PRODUCT SUPPORT BULLETIN BULLETIN NO. 317

MACHINE: **Hydra-Hammer Model B, B-2, Model C, 99C**

SUBJECT: **Anvil Tip 10560029**

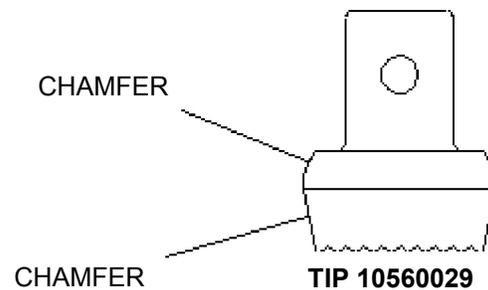
Anvil Tip p/n 10560018 has been replaced by **Anvil Tip p/n 10560029**.

Tip 10560029 has been designed to correct the field problems associated with Tip 10560018. The radius between the stem and the base of the tip has been increased to prevent cracking in this area. Chamfers have been added to the top surface of the base to prevent the tip from being caught on track bolts, etc. This will also help prevent tip breakage.

In addition, a solid drive pin, **p/n 53644000**, has replaced the roll pin, **p/n 53643950** which had been used to attach the tip to the anvil extension. This solid pin will eliminate reported problems with pin breakage. Since the solid pin "bites" into the anvil tip when installed, pin movement problems will be eliminated as well. **Anvil Tip p/n 10560029 will include one 53644000 pin.**

All orders for Anvil Tip 10560018 will be filled with Anvil Tip 10560029. Please contact the NORDCO Parts Department for additional information.
